RIVER TRAIL WEST AMENITY REFRESH

DEMO PLAN - E. MAIN AVE -
CENTRAL

RIVER'S TRAIL EAST AMENITY REFRESH

DA1.6

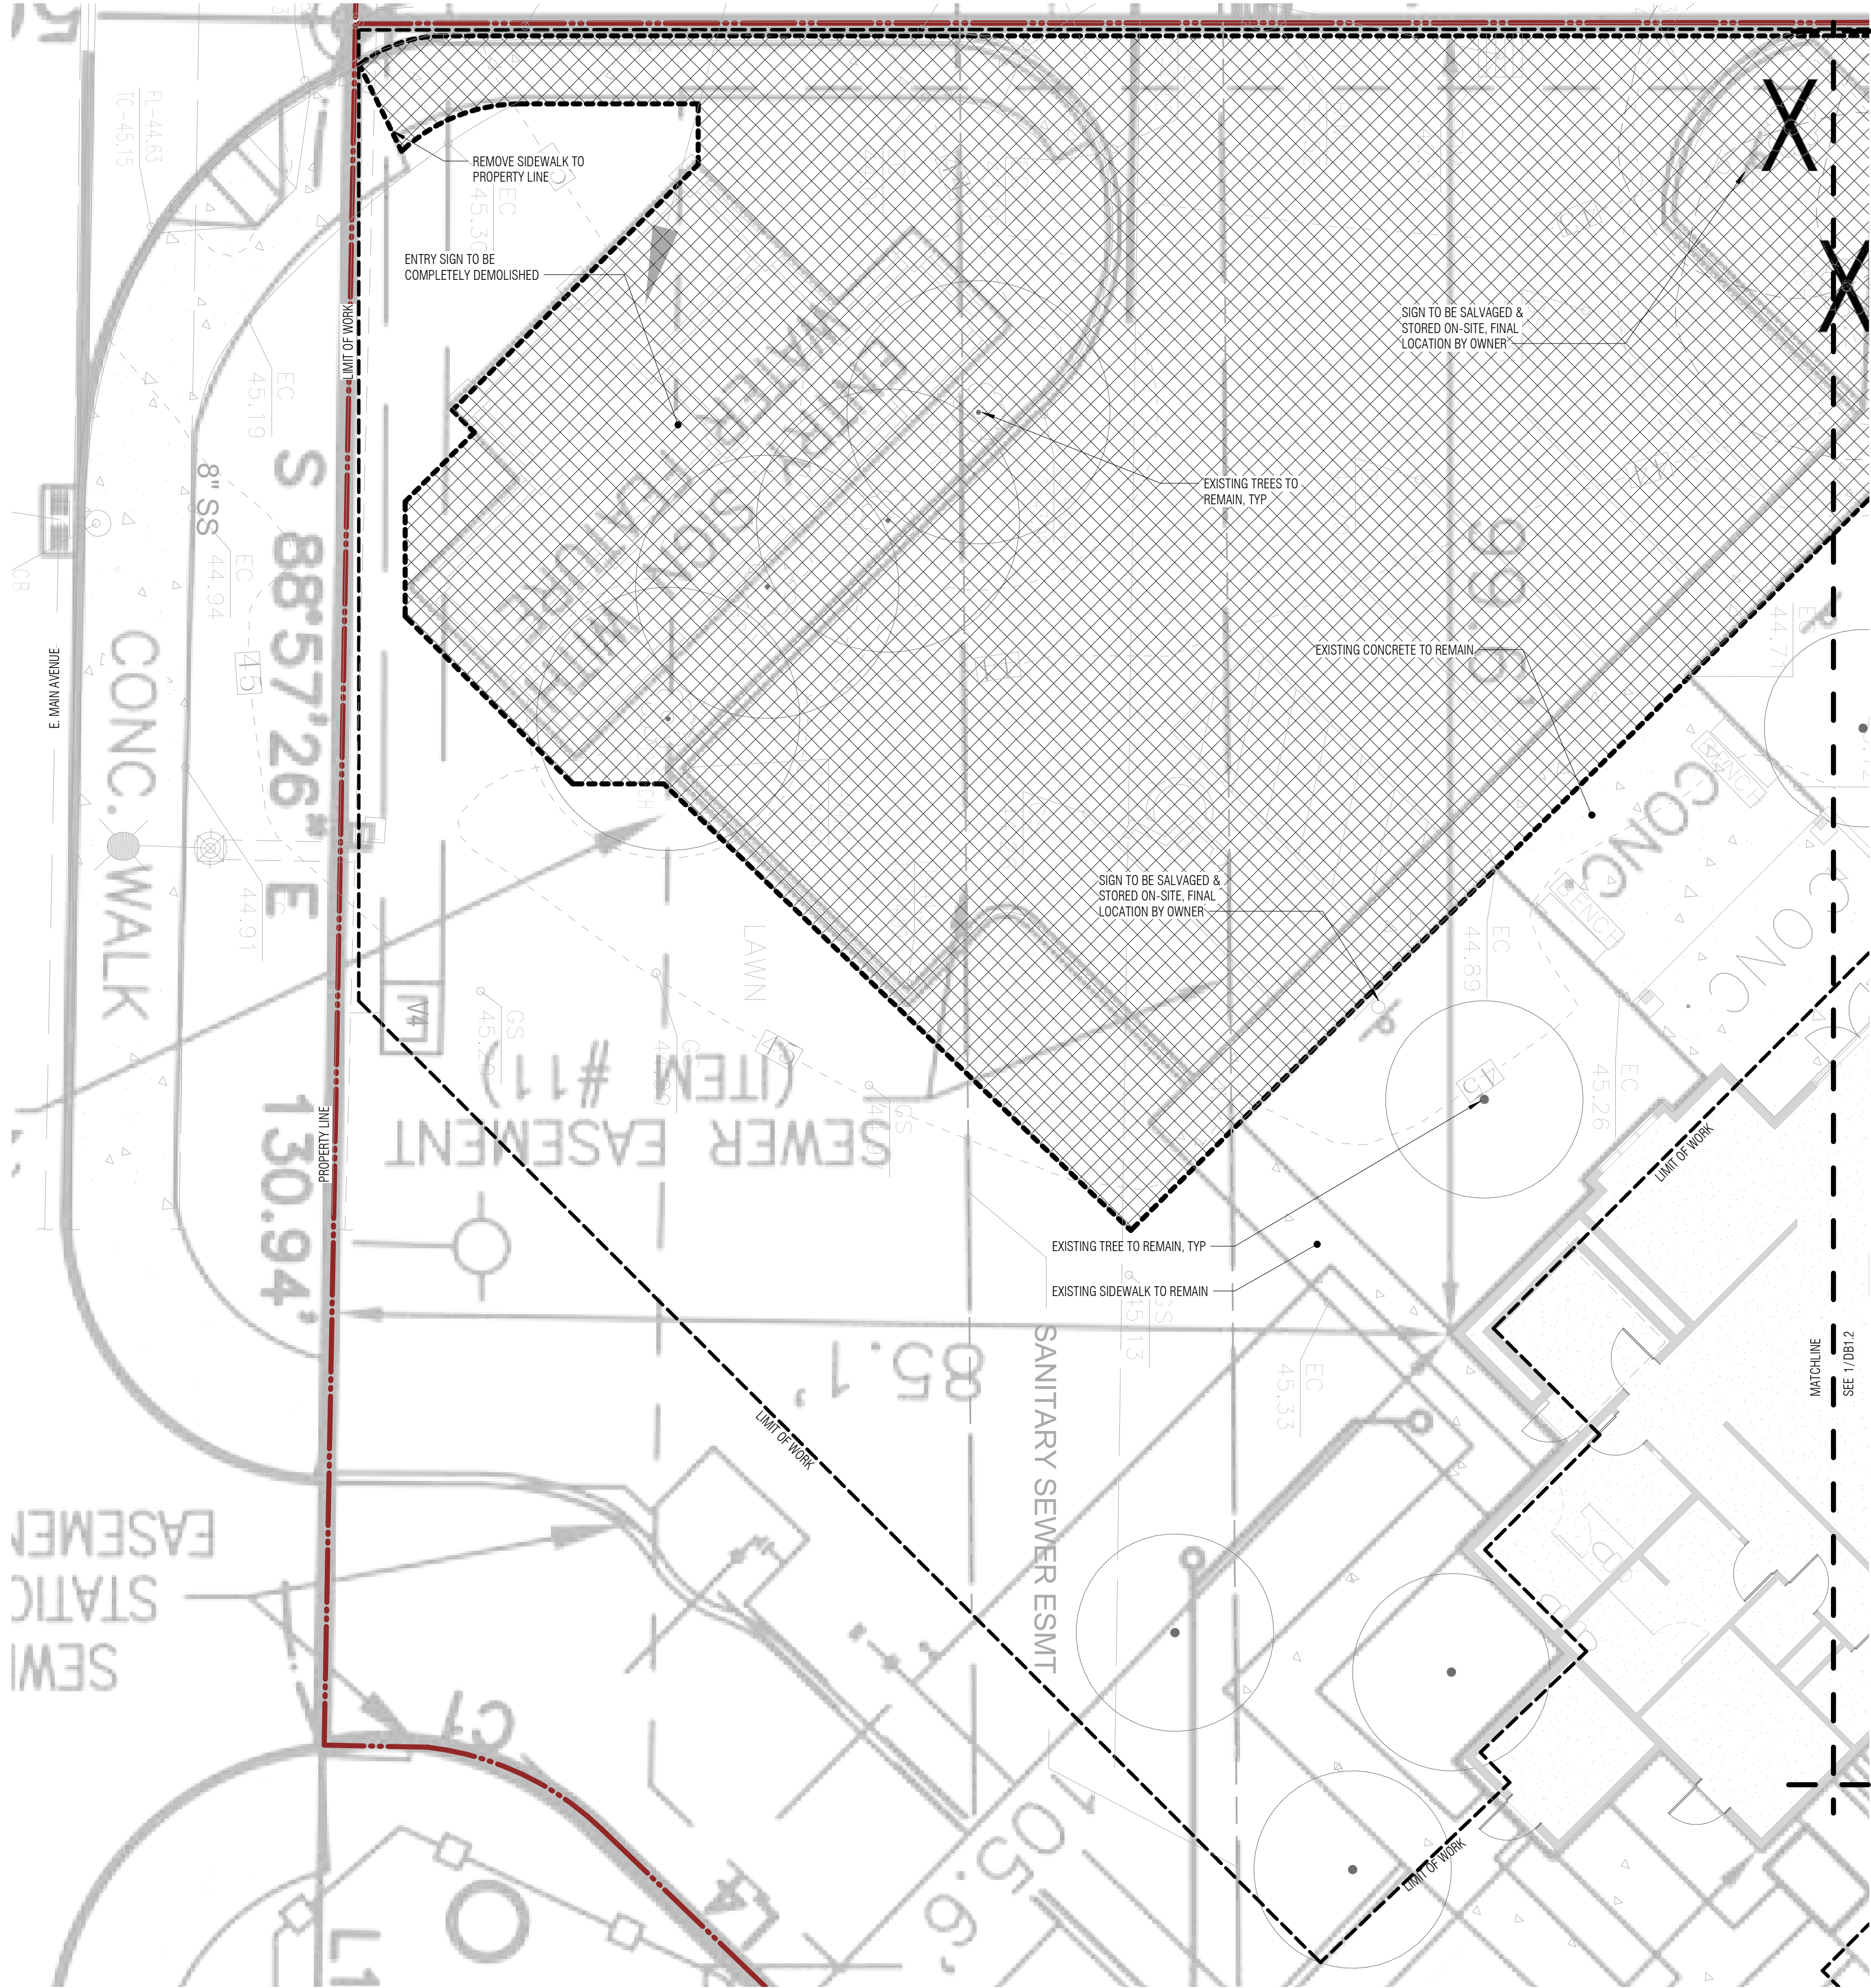
Each tree will need to be replaced at a ratio of 1:1. Please note on the plans where these trees will be replaced. [landscape sheets, pg. 4]

PLANTING PLAN - E. MAIN
AVE - CENTRAL

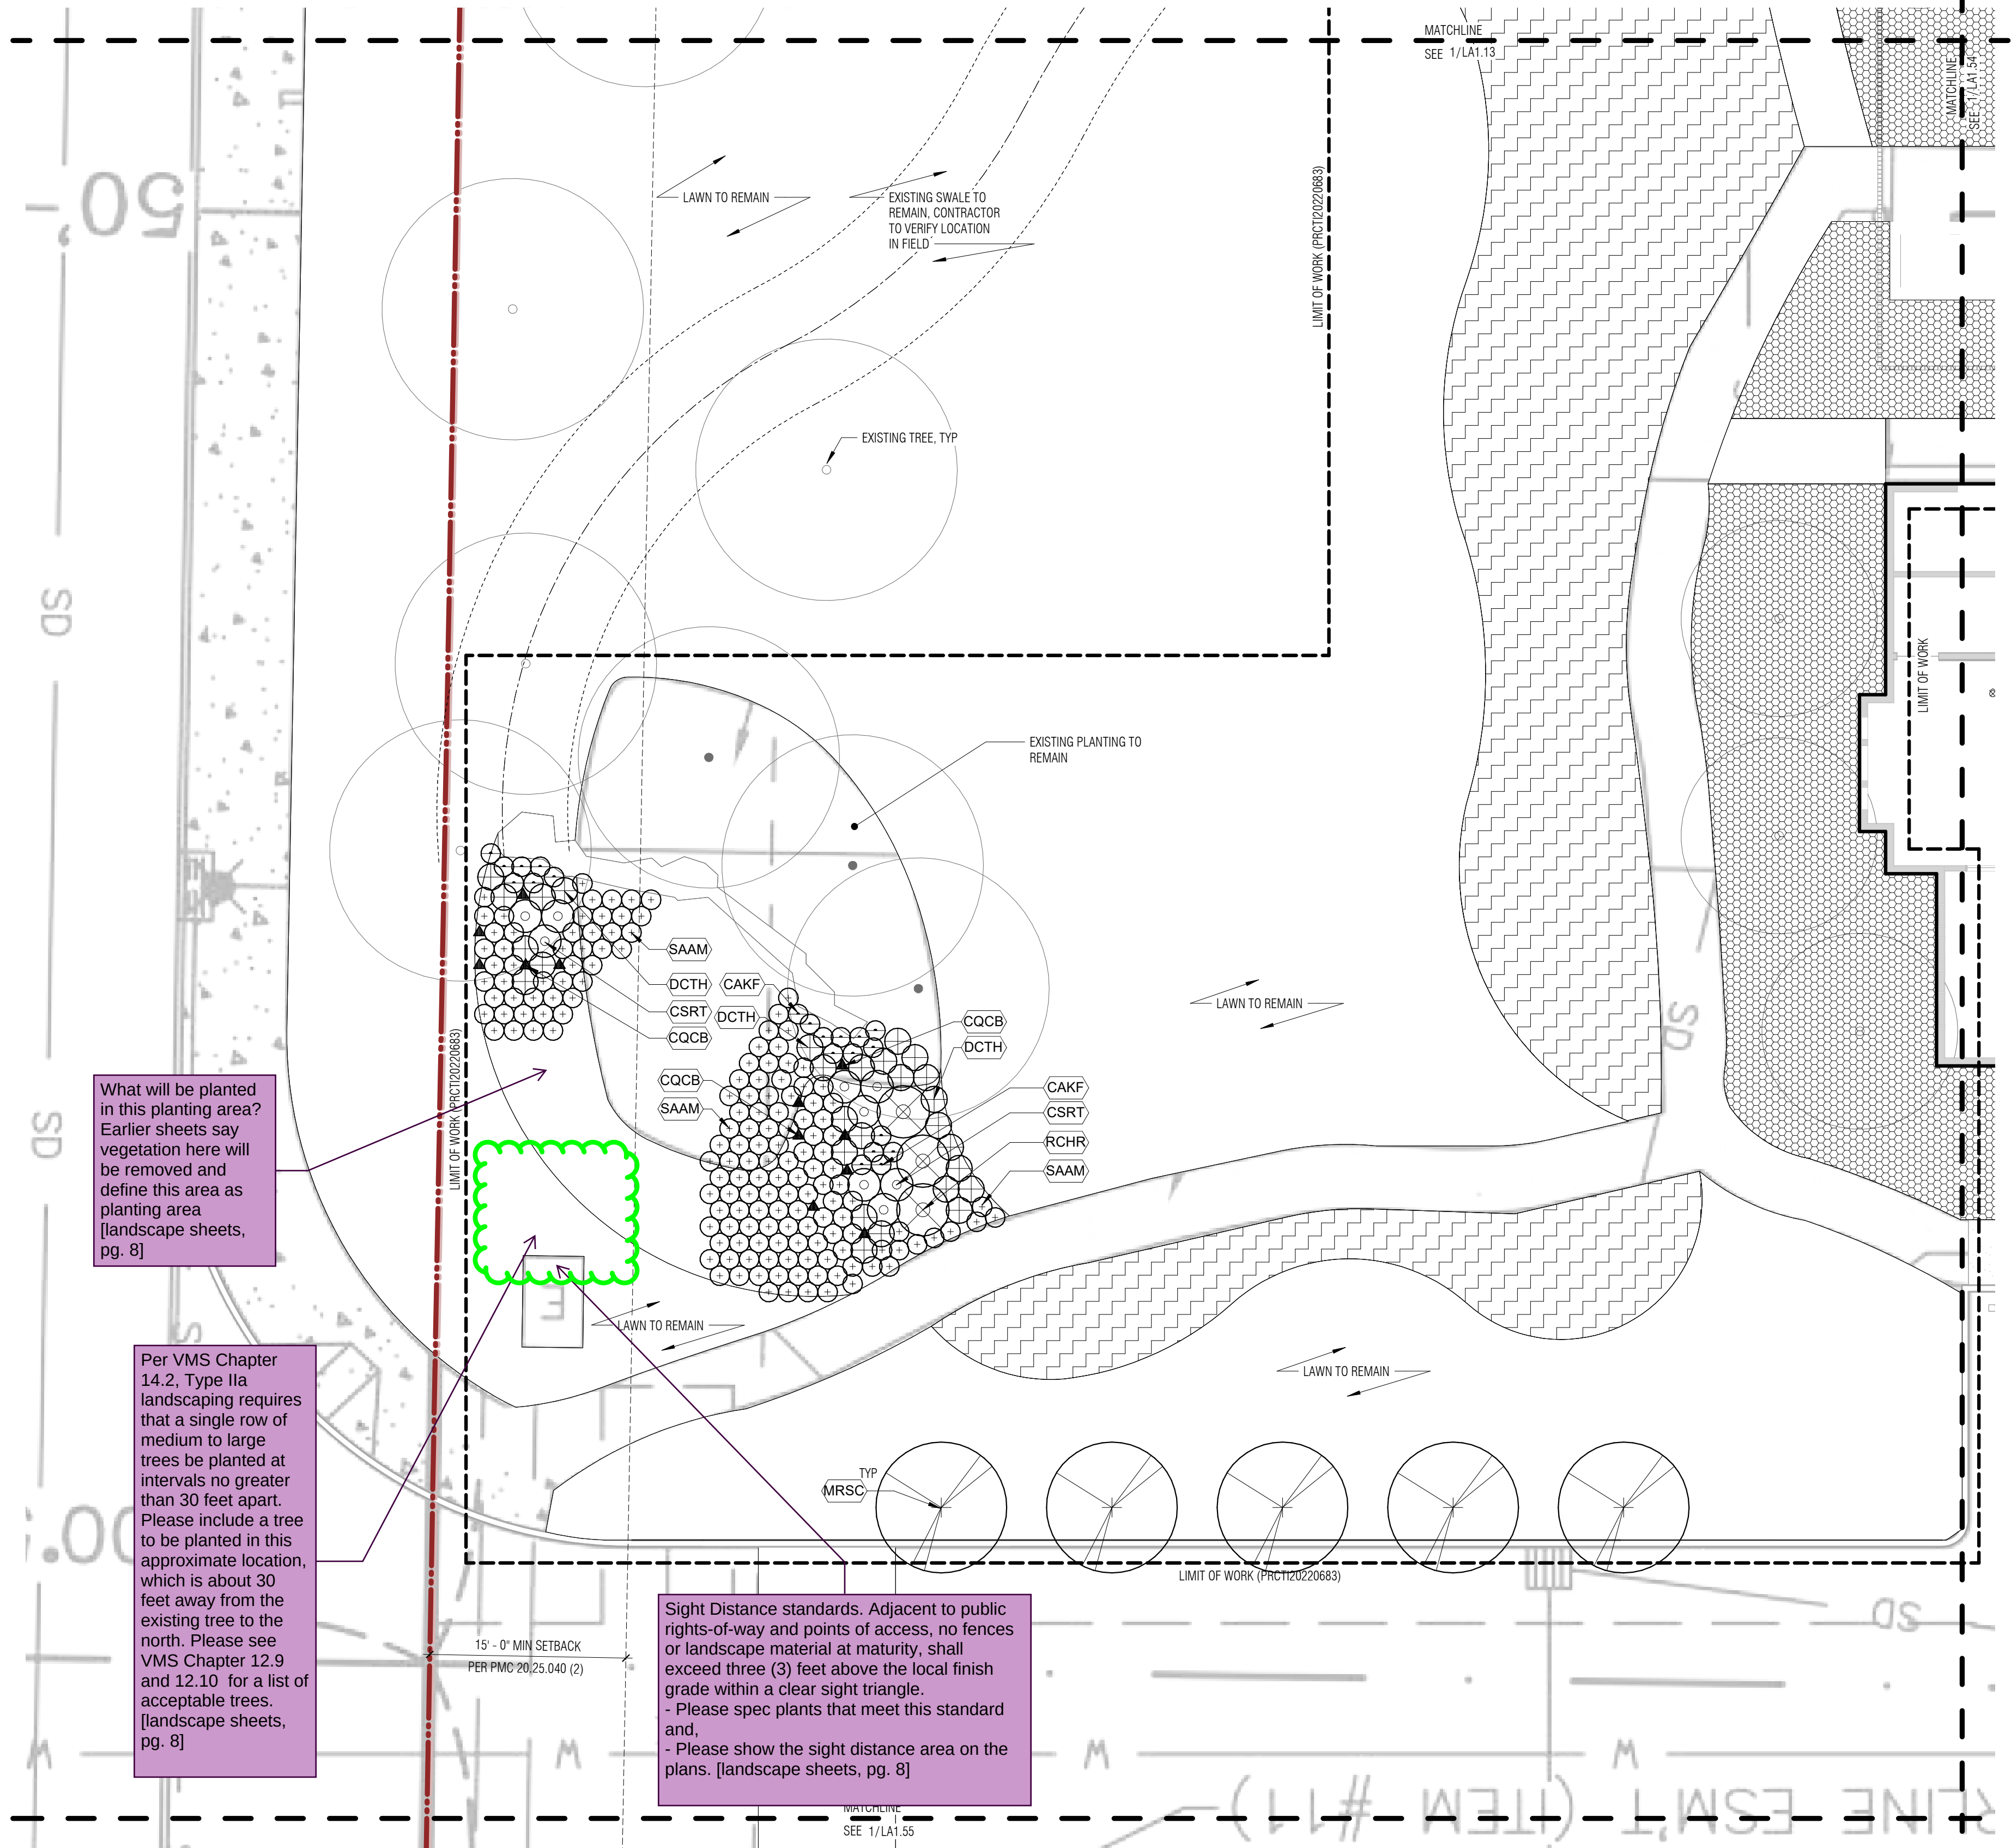
What will be planted in this planting area? Earlier sheets say vegetation here will be removed and define this area as planting area [landscape sheets, pg. 8]

Per VMS Chapter 14.2, Type Iia landscaping requires that a single row of medium to large trees be planted at intervals no greater than 30 feet apart. Please include a tree to be planted in this approximate location, which is about 30 feet away from the existing tree to the north. Please see VMS Chapter 12.9 and 12.10 for a list of acceptable trees. [landscape sheets, pg. 8]

Sight Distance standards. Adjacent to public rights-of-way and points of access, no fences or landscape material at maturity, shall exceed three (3) feet above the local finish grade within a clear sight triangle.
- Please spec plants that meet this standard and,
- Please show the sight distance area on the plans. [landscape sheets, pg. 8]
